CENTRAL MAIZE SCHOOLS ADDITION

RE: SUB 2000-58 -- Final Plat of Central Maize Schools Addition

RE: SUB 2000-58 -- Final Plat of Central Maize Schools Addition

CASE NUMBER: SUB 2001-58 -- CENTRAL MAIZE SCHOOLS ADDITION

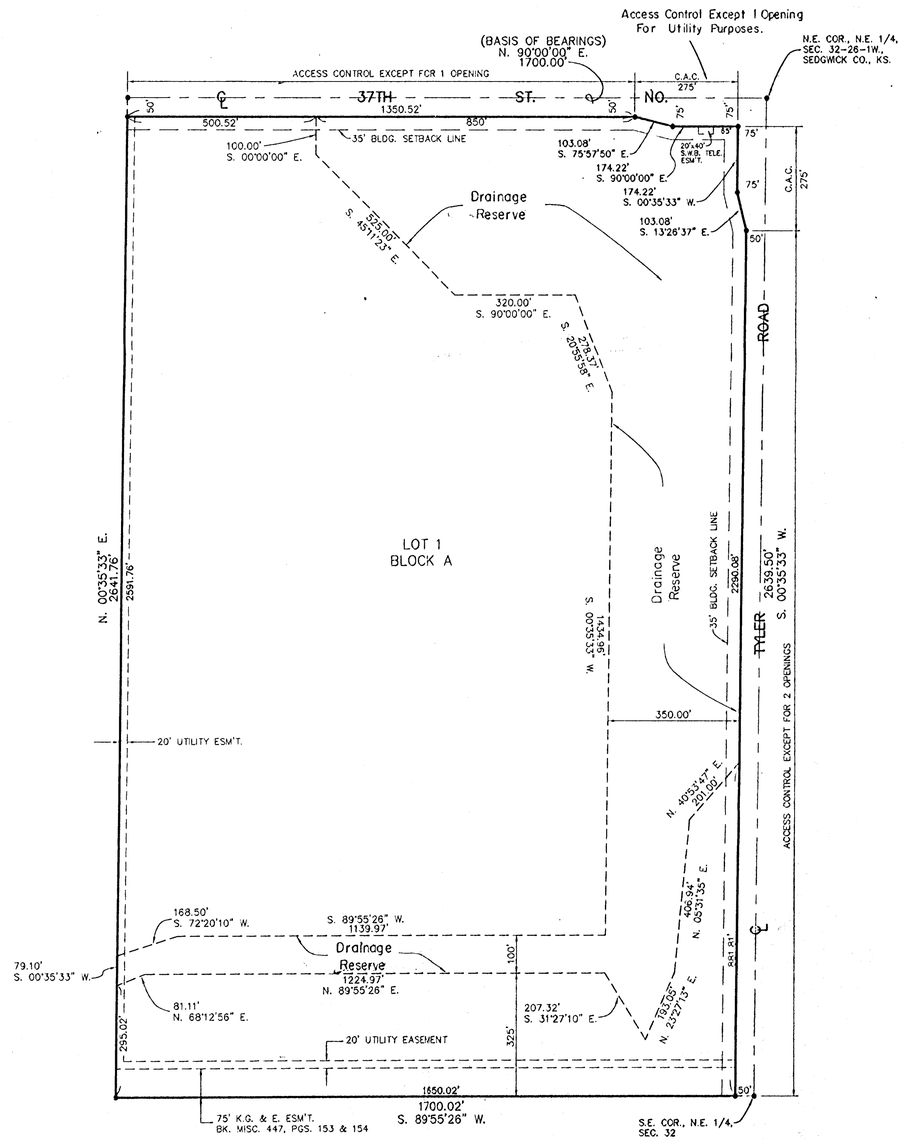
C. County Engineering needs to comment on the status of the applicant's drainage plan. *County Engineering has requested that the Applicant provide on-site detention ponds. Drainage discharge shall be limited to the capacity of the existing drainage structures. A Master Drainage Plan is needed.*

E. County Engineering needs to comment on the need for access controls. The final plat shall reference the access controls in the plattor's text. *County Engineering has required 250 feet of complete access control at the intersection. County Engineering has recommended one access opening along 37th St. and two access openings along Tyler. County Engineering also advises a potential need for an access opening for the existing Southwestern Bell substation, and requests the platting of its associated easement on the final plat tracing.*

H. The purposes of the reserve need to be referenced in the plattor's text.

I. The language in the plattor's text needs to be revised to reference "Lot 1, Block A" instead of "the adjacent property owners" in regards to the responsibility of Reserve A.

J. Reserve A needs dimensions at the following locations: along the west line of Lot 1 from the southwest corner; from the south line, of the portion running parallel to the south line of lot 1, to the south line of Lot 1; the width of the portion running parallel to the south line of Lot 1; and the width of the portion running parallel to the east line of Lot 1.

L. The plattor's text shall include language that a drainage plan has been developed for the plat and that all drainage easements, rights-of-way, or reserves shall remain at established grades or as modified with the approval of the applicable City or County Engineer, and unobstructed to allow for the conveyance of stormwater.
